ADDENDUM NO. 1

LALAMILO HOUSING PHASE 2A, INCREMENT 1, (PART I) AND
LALAMILO HOUSING PHASE 2A, KAWAIHAE ROAD IMPROVEMENTS
AT SOUTH KOHALA DISTRIBUTION ROAD (PART II)
(IFB-12-HHL-008)

WAIMEA, SOUTH KOHALA, ISLAND OF HAWAII, HAWAII

DWG. NO. C-11 SHEET 12 OF 70 SHEETS

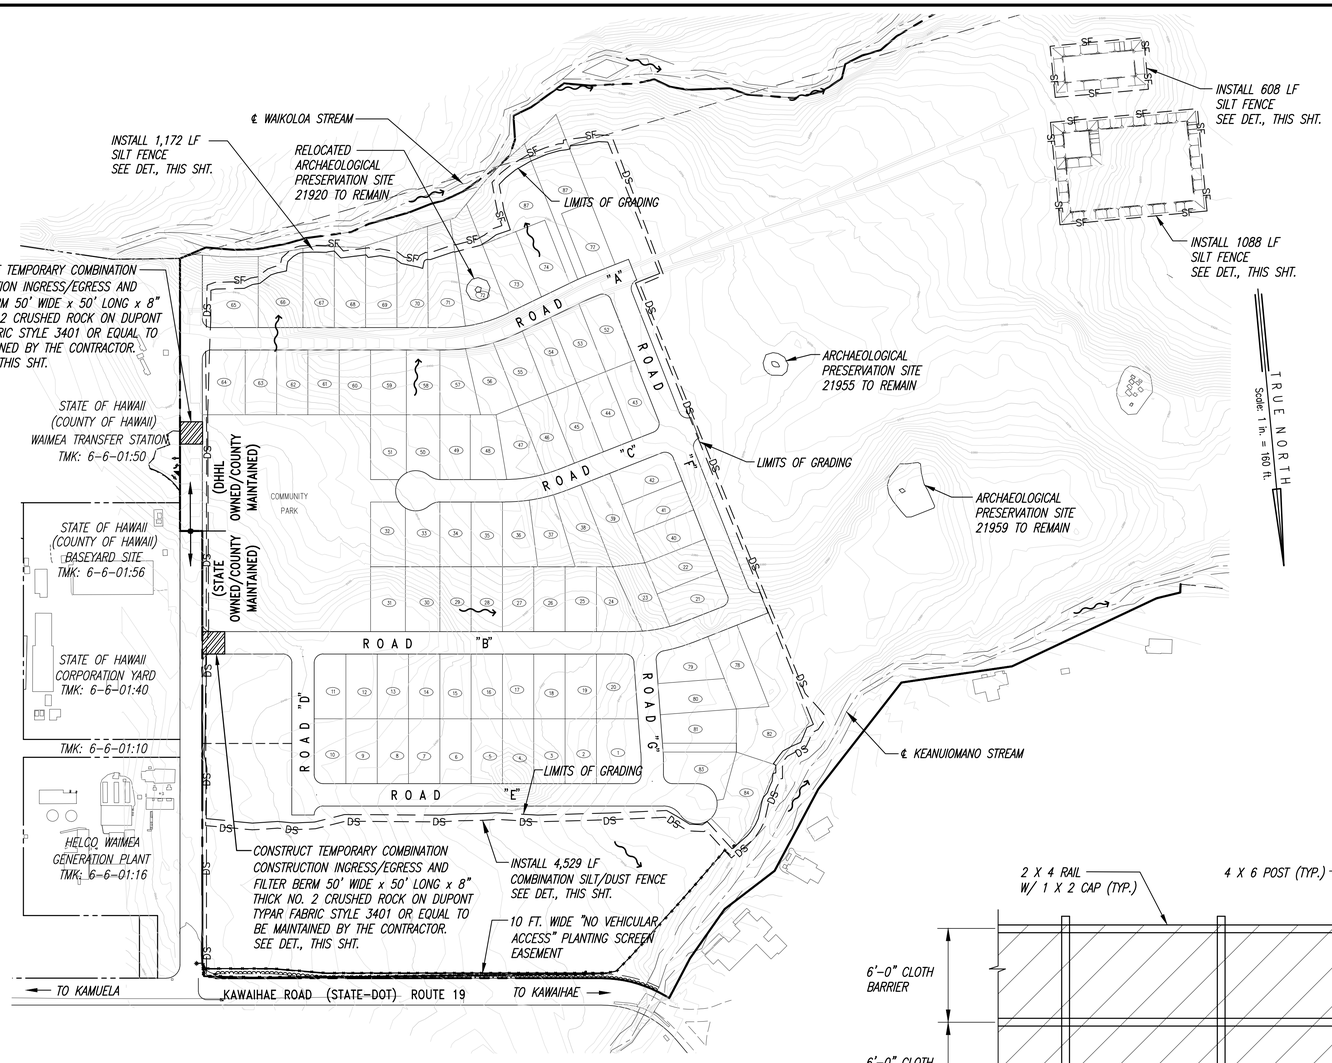
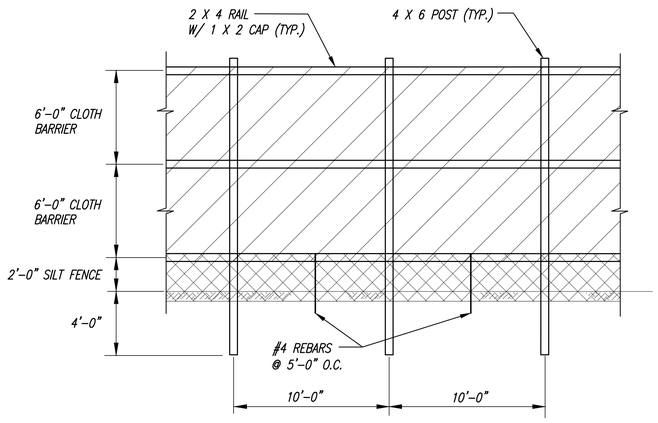
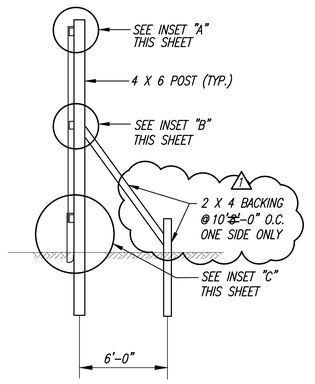
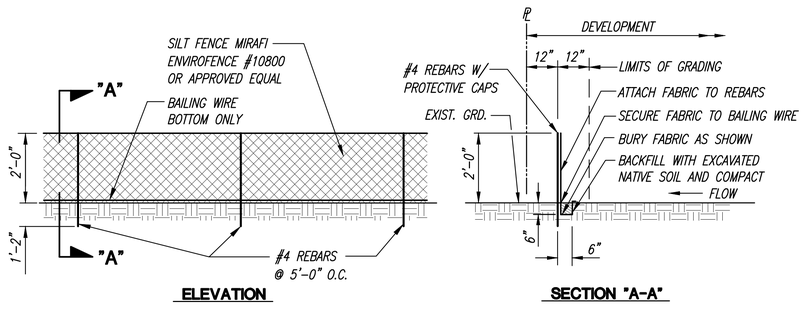
Drawing No.	Sheet No.	Description
Lalamilo Housing Phase 2A, Increment 1		
C-11	**12**	**Erosion Control Plan**
		Revised silt/dust fence detail.
C-12	**13**	**Demolition Plan**
		Revised callout "EXISTING CHAIN-LINK FENCE" to "EXISTING BARBED WIRE FENCE"
C-15	**16**	**Plan and Profile Road "B" STA. 0+00 to 11+00**
		Removed GSP work
C-22	**23**	**Plan and Profile South Kohala Distribution Road STA. 0+00 to 9+00**
		Revised curb data, removed guard rail and GSP work, and revised notes.
E-1	**1**	**Electrical Symbols, Maps, Notes**
		Added note "h" under "Notes for Construction" to point out that the contractor should
		refer to HELCo drawings for construction of HELCo facilities.
E-3	**2**	**HELCO Notes**
		Revised notes to show current HELCo contact information.
E-8	**3**	**Typical Duct Section I**
		(Sheet)
		Added note 6 under "Notes" to point out that the contractor should refer to HELCo
		drawings for construction of HELCo facilities.

For the dust fencing shown on Sheet C-11 will substituting metal pipe of a suitable grade, diameter and schedule in lieu of 4x6 wood posts be acceptable? The metal pipe fences tend to perform better and cost less for this area of application in Waimea. Eliminating the dust fence would be preferable making dust control fully the contractor's responsibility. The dust fences in the Waimea area typically do not perform their intended function very well and typically become a tattered eye sore to all.

DWG. NO. C-22 SHEET 23 OF 70 SHEETS

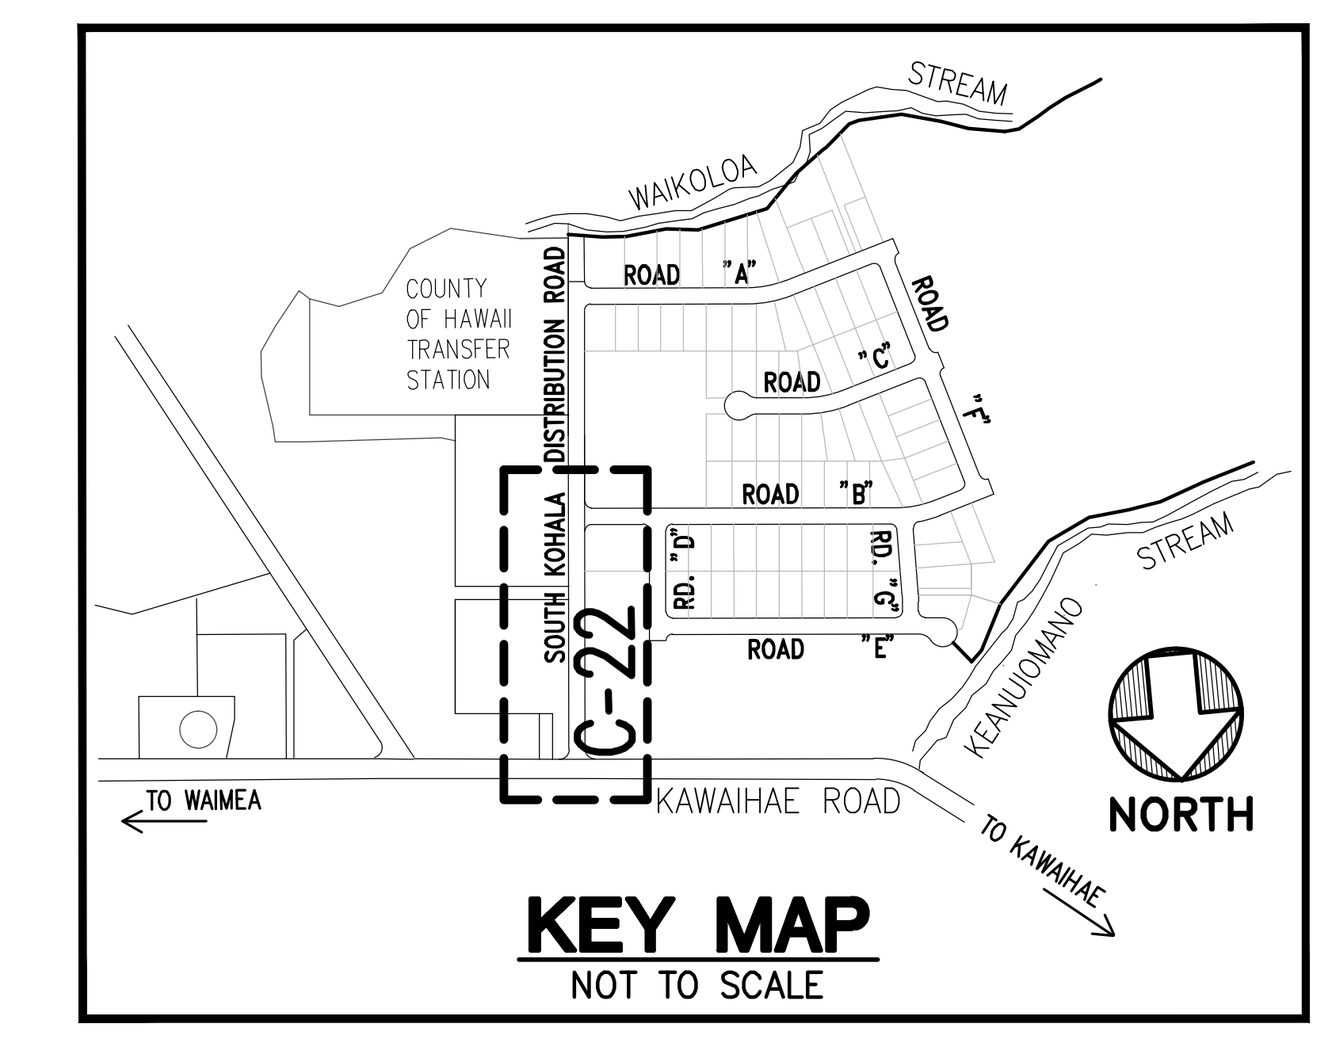
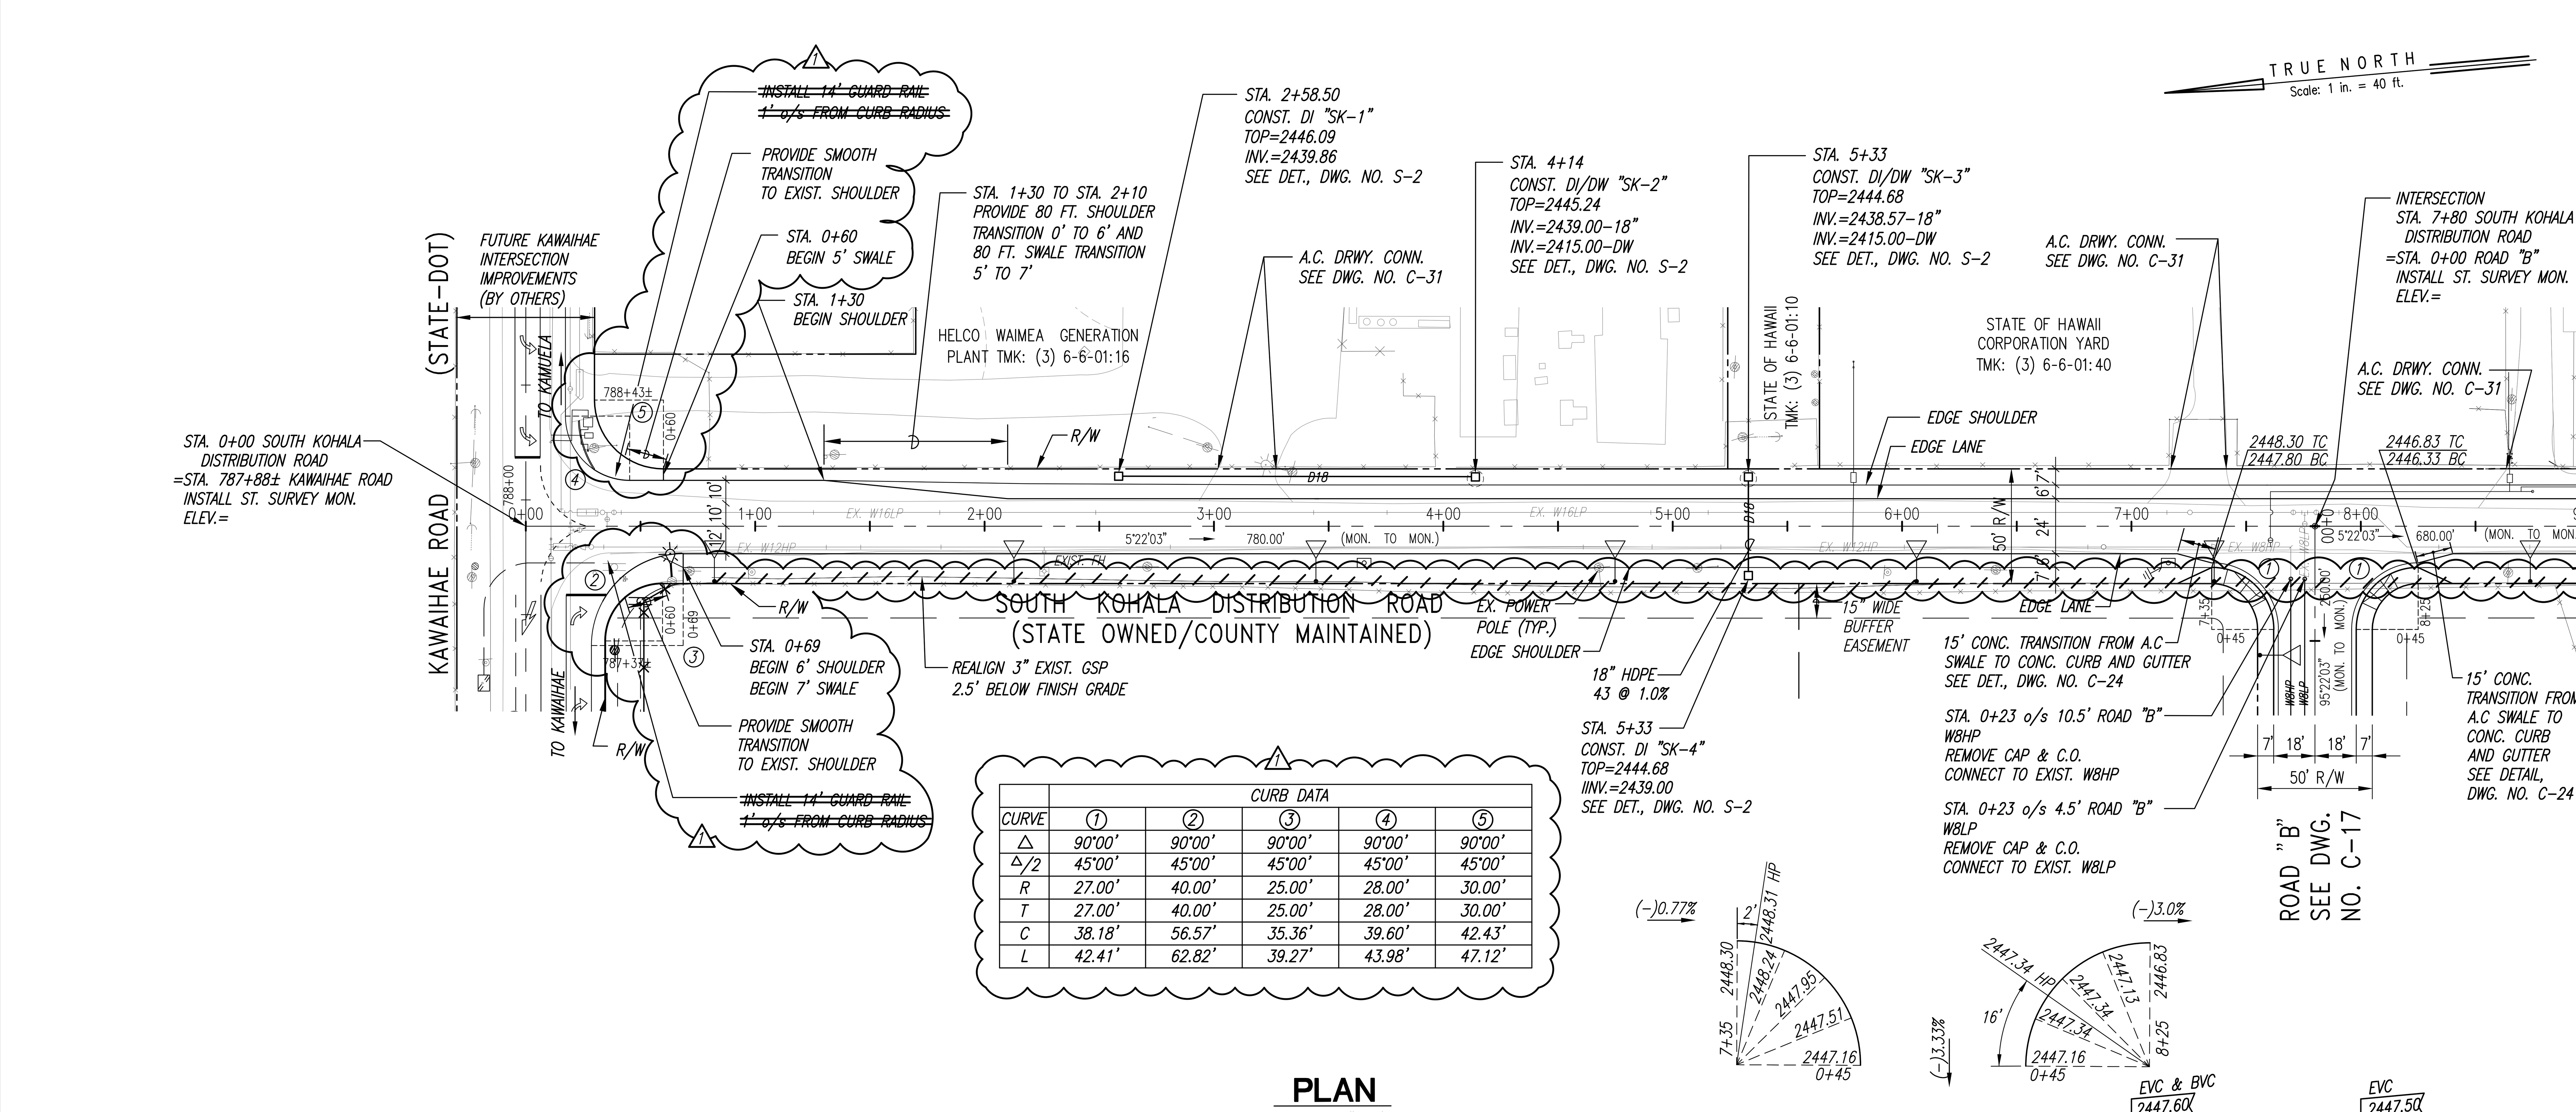
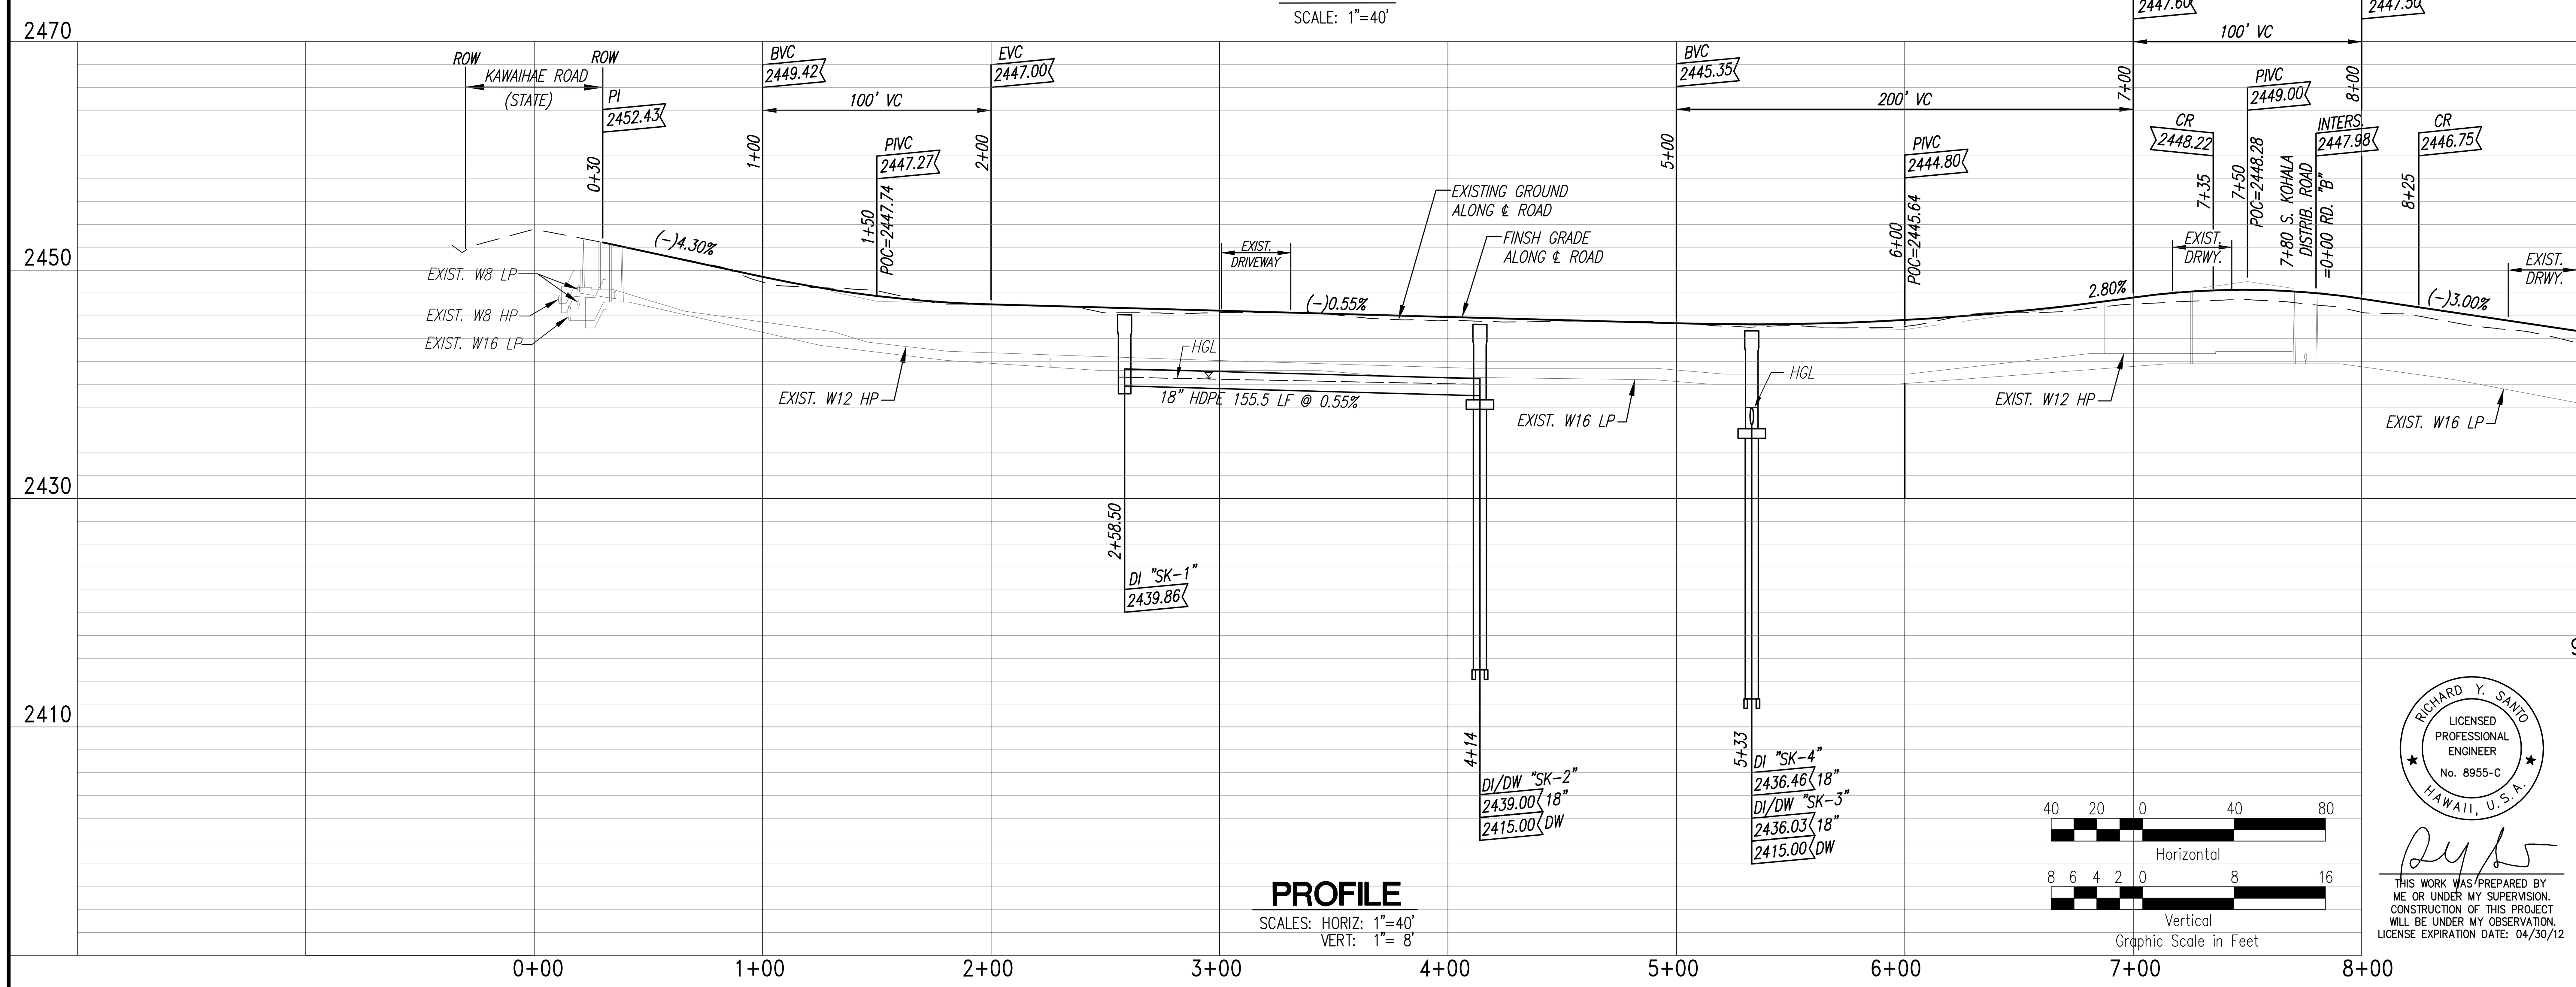
1. ~~IMPROVEMENT TO KAWAIHAE ROAD UNDER SEPARATE FUTURE PROJECT (BY OTHERS).~~

DWG. NO. E–4 SHEET 4 OF 4 SHEETS

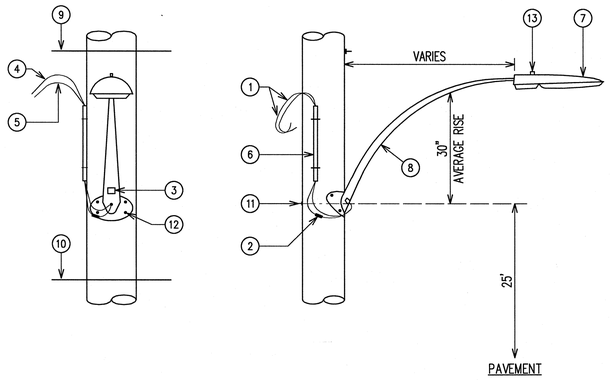
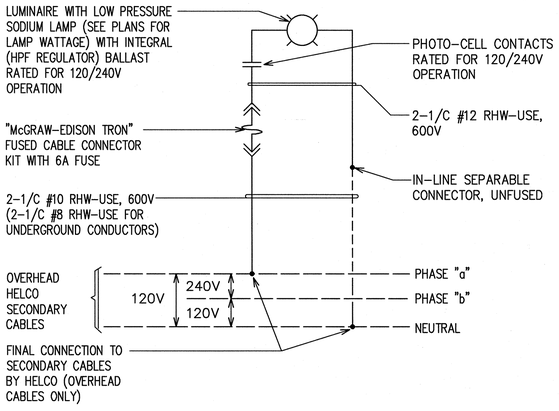
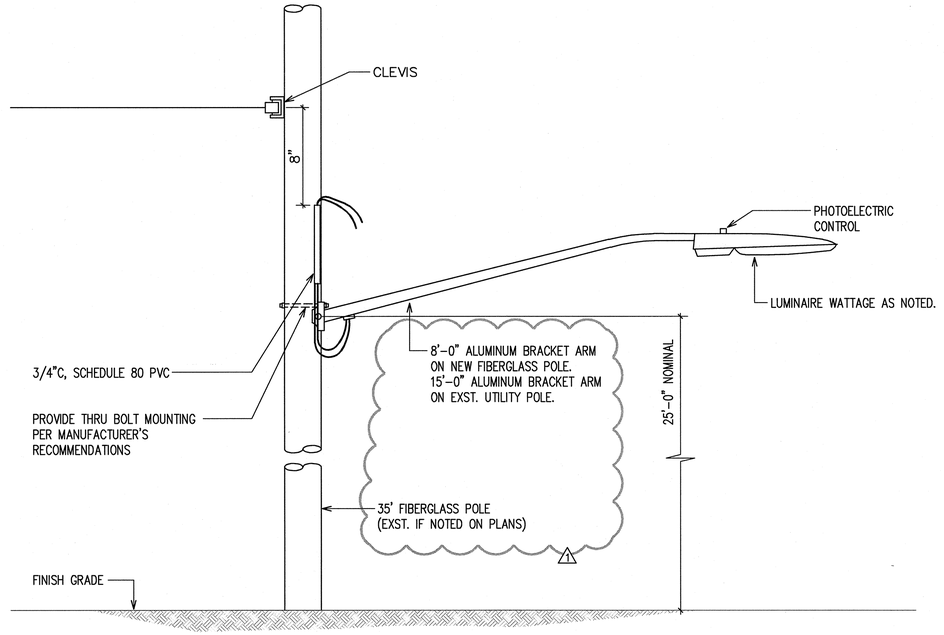
Lalamilo Housing Phase 2A Kawaihae Road Improvements at South Kohala Distribution Road		
E-4	**4**	**Street Light Details**
		Added DPW Street Lighting Notes.
		Revised street light arm length for existing and fiberglass poles.
HELCO	**5**	**HELCO Drawing 10-E-464**
DWG		(Plan)
		Added HELCo drawings. 4 Sheets total.
